**WORCESTER COUNTY TECHNICAL REVIEW COMMITTEE
AGENDA**

A. Woodside Solar – Major Site Plan Review

B. Snow Solar – Major Site Plan Review

PROJECT: Woodside Solar – Major Site Plan Review

7 DETAIL SIGNAGE (TYP.) NOT TO SCALE

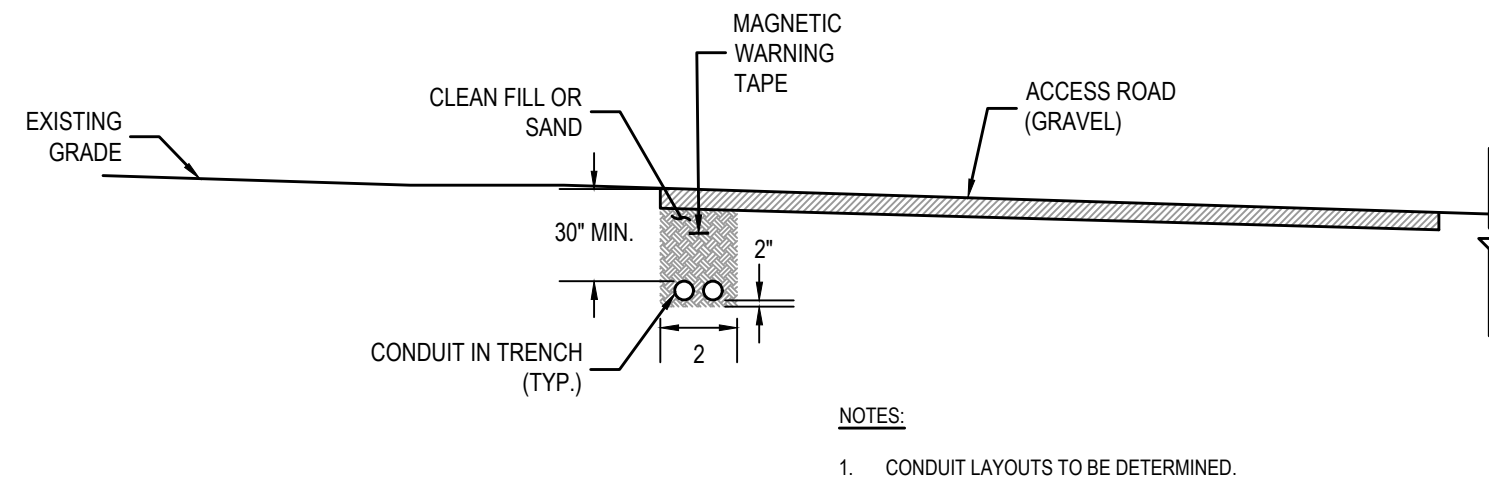
1. Please show the signage that is shown on typical detail #7 on Sheet C-SP-3.0.
2. Sheet C-SP-2.0: Please clarify if Emergency Services has been notified. Public Utilities Article §7–218(f)(2)(vii).
3. Sheet C-SP-2.0: Please clarify that no topsoil shall be removed from the parcel, although it can be moved or temporarily stockpiled for grading. Public Utilities Article §7–218(f)(5)(i)-(v).

PROPOSED SITE DETAILS

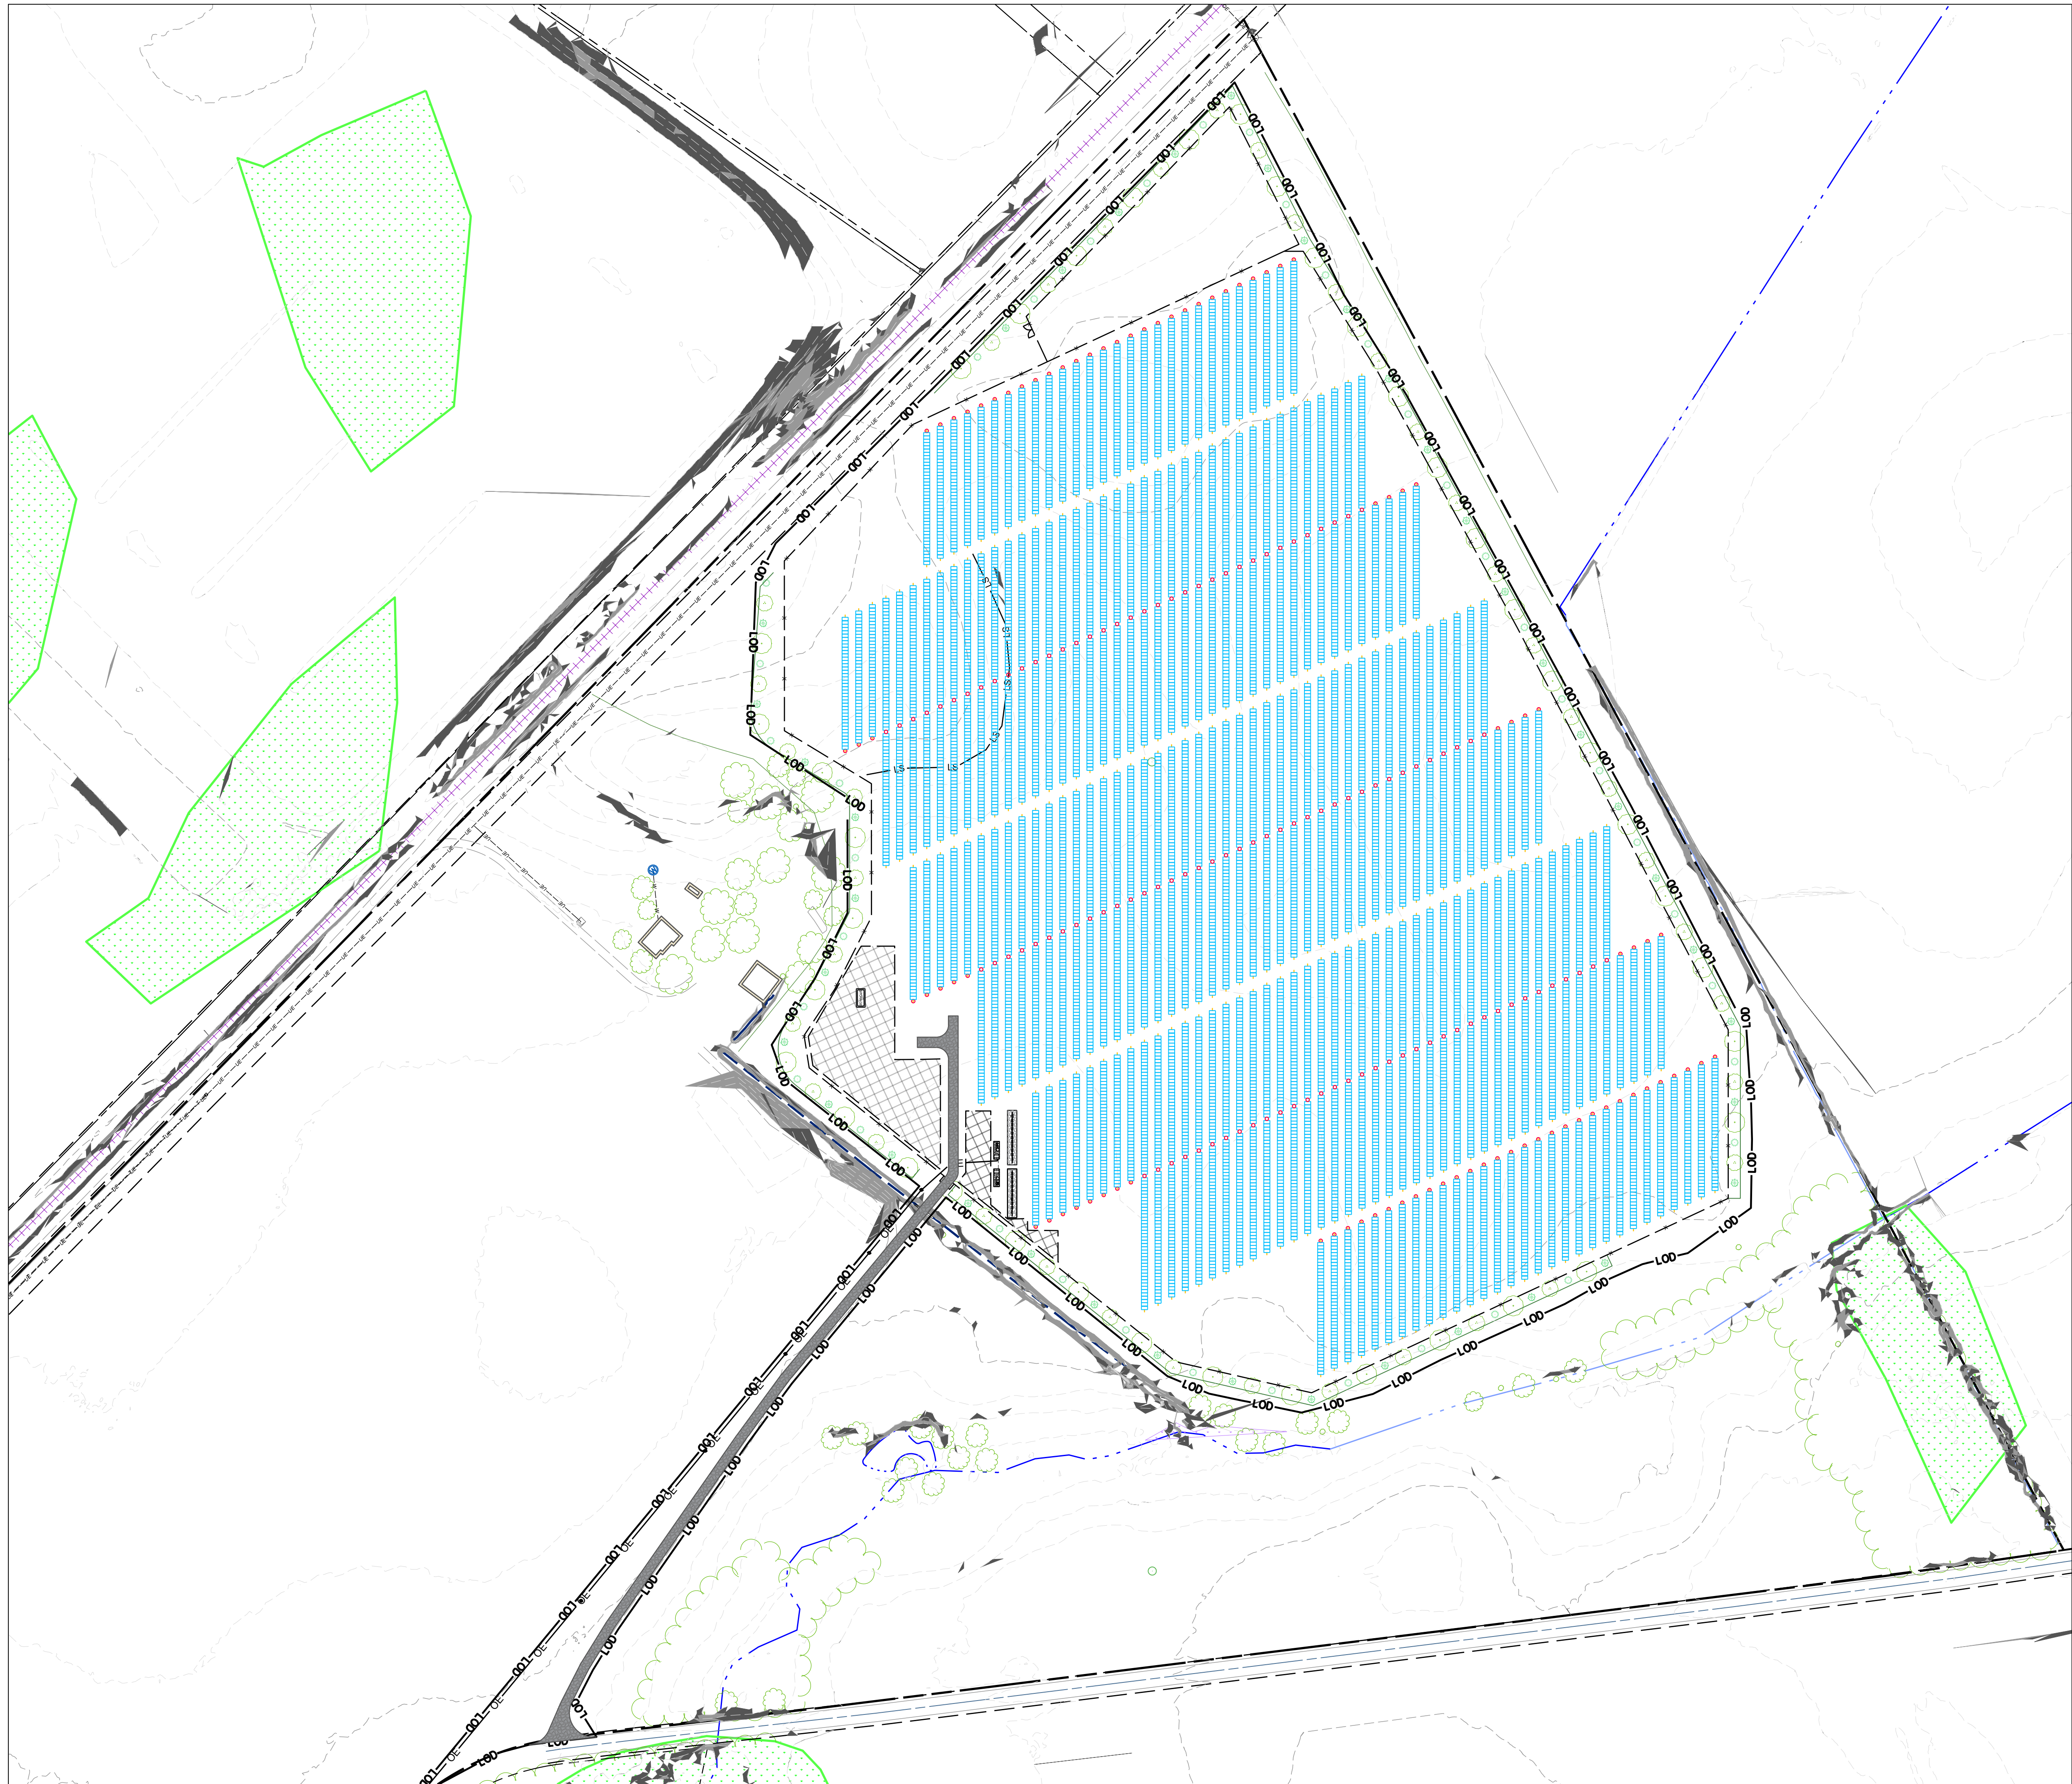
1. Sheets 3 & 4: Please clarify if the proposed 12' wide access drive will be for one-way traffic. If it is for two-way traffic, then it will need to be widened to 20.'
2. Sheets 3 & 4: Please show the signage that is shown on typical detail #9 on sheet 5.

PLANTING DETAILS

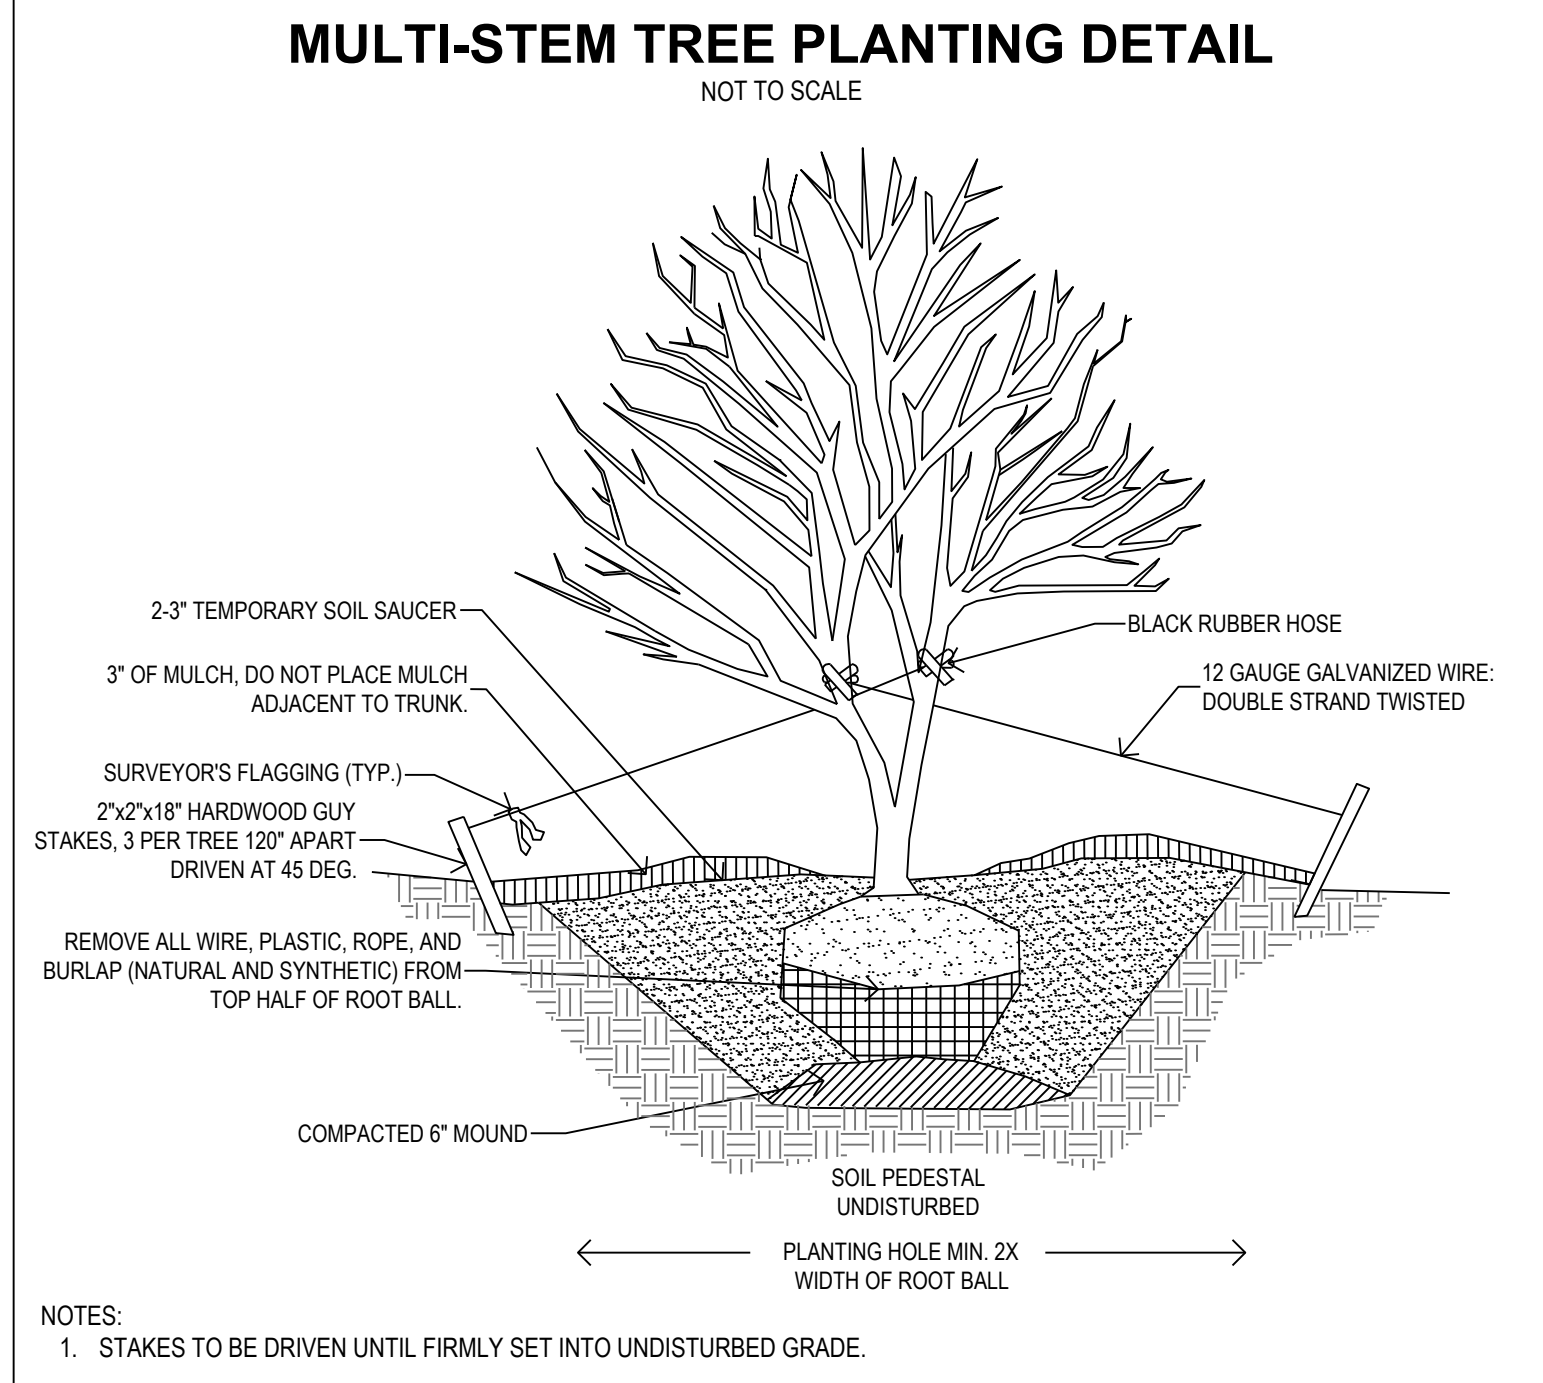
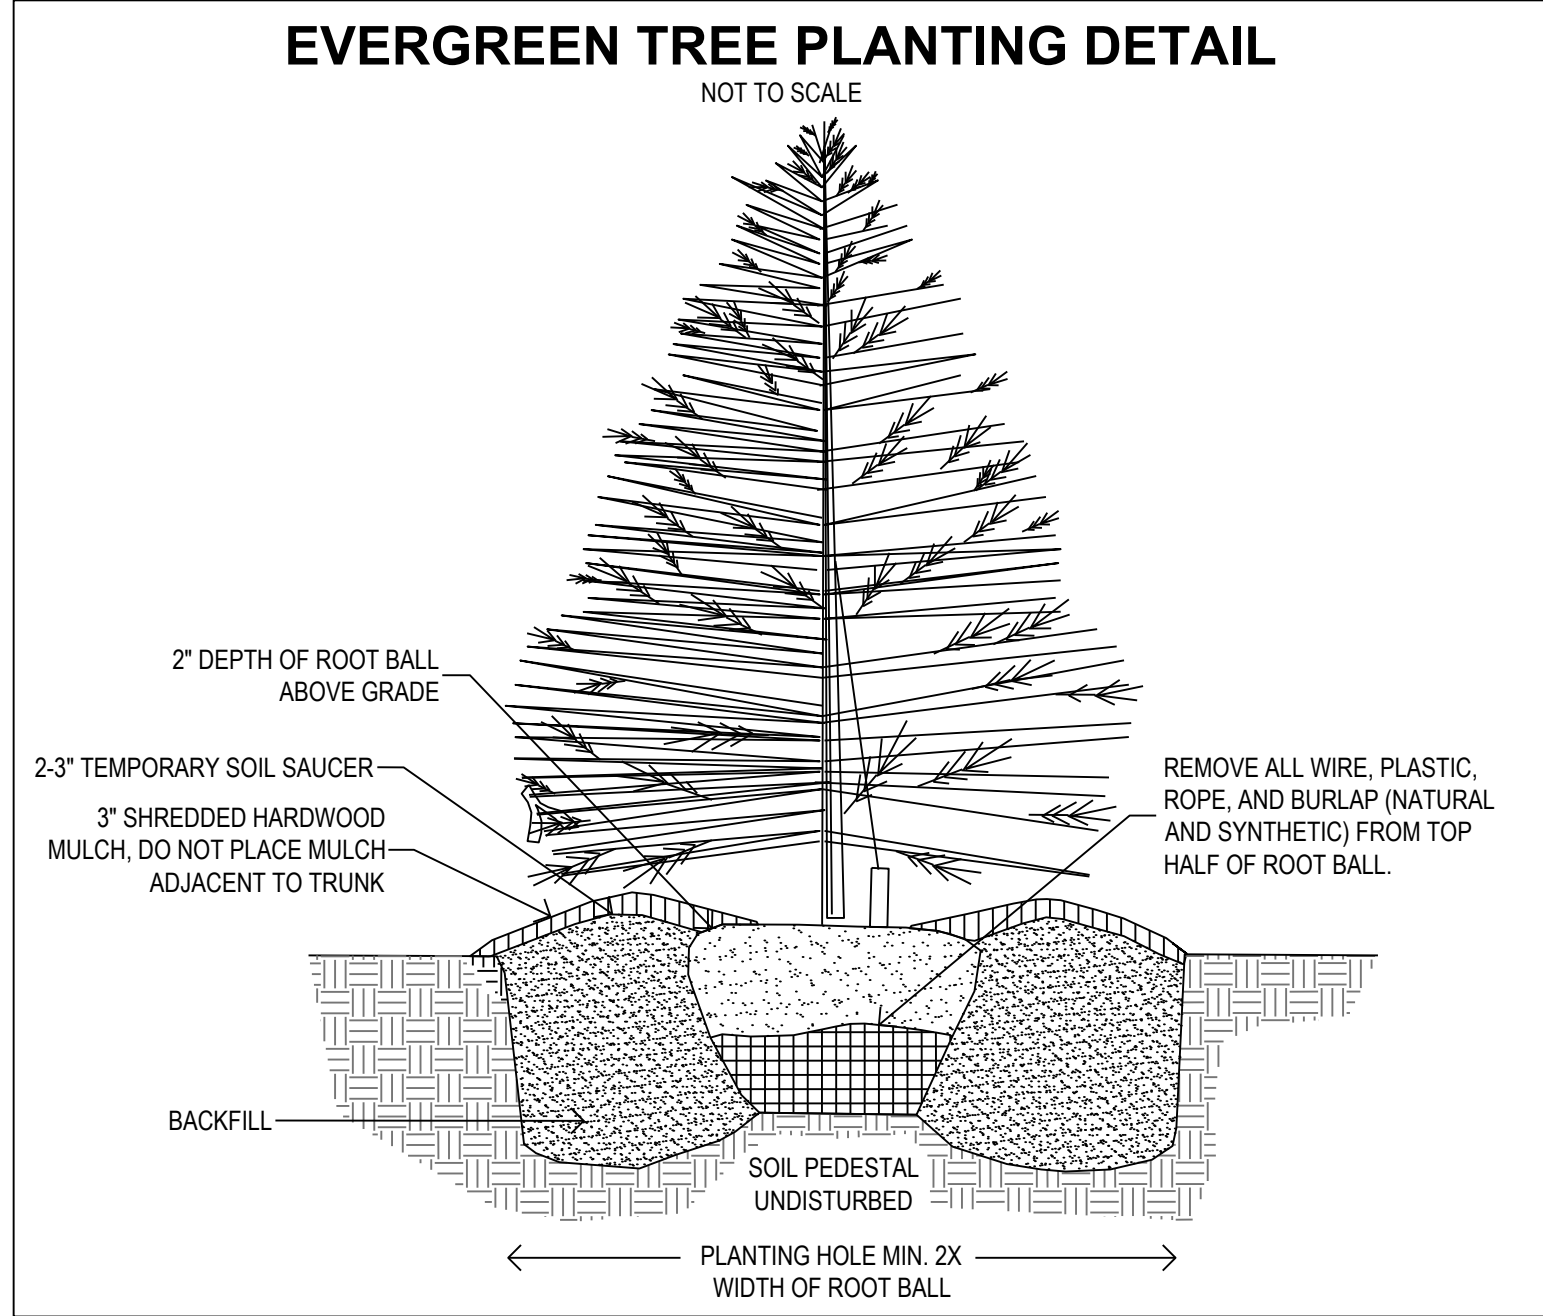
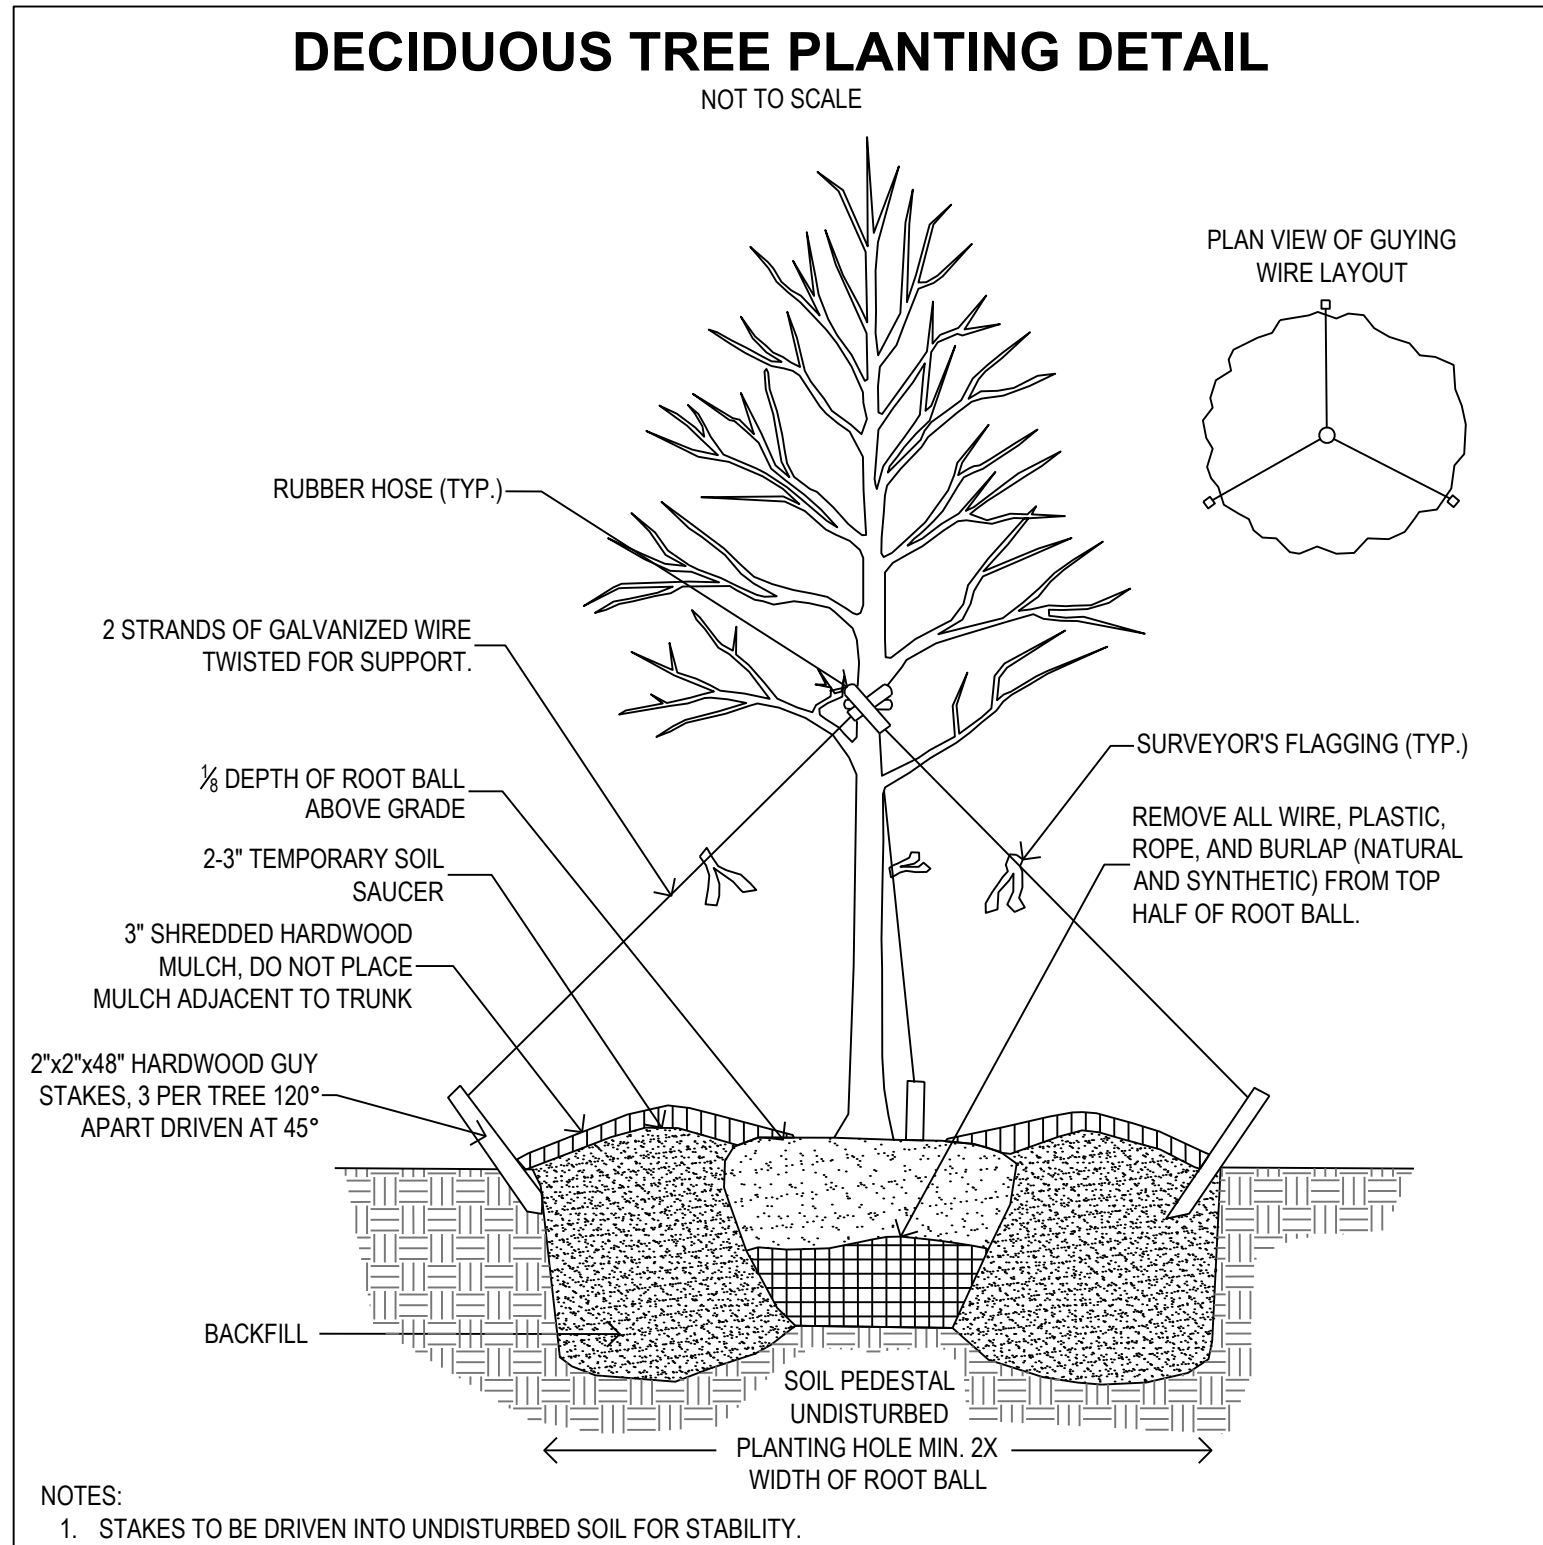
2. Sheet L2.0: Please add that any changes and substitutions to the landscaping plan shall be approved by Worcester County.
3. Sheet L2.0: Please provide the landscaping height and caliper of all proposed landscape material at the time of planting and maturity. §ZS1-322(d)(5).

4. Sheet L2.0: Please provide a native species percentage calculation, as 75% of the species must be native to Worcester County. §ZS1-322(b)(7).
5. Sheet L2.0: Within Note #4 in the Installation Notes, please also add that changes in planting locations must also be approved by Worcester County.

6. Sheet L2.0: Please provide a typical detail for the landscape buffer row.
7. Sheet L2.0: Please specify the landscaping maintenance system or watering plan. Per County code: "Each landscaped area must be readily accessible to a water supply. Unless xeriscaping plant material and technologies are employed, all landscaped areas shall provide an automatic irrigation system with rain sensors. Drip irrigation systems are preferred. If an automatic system is not feasible, the Planning Commission at its discretion may approve an alternate watering system to maintain the plant material." §ZS1-322(b)(7).
